Access Compliance Report Public Rights-of-Way (Curb Ramps)

Intersection ID: 16186 Main Street: POINDEXTER DR **Cross Street: WINDSOR AV** Location: N ADA ID: 0F8BB985C5E2 Ramp Type: BlendTrans2 Initial Pass/Fail: Fail **Overall Compliance: No** 1.25 **Severity Score:**

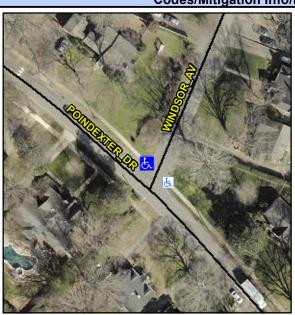
Not Found, R304.5.3

Remove & Replace Curb Ramp With Two New Directional Ramps or Equivalent.
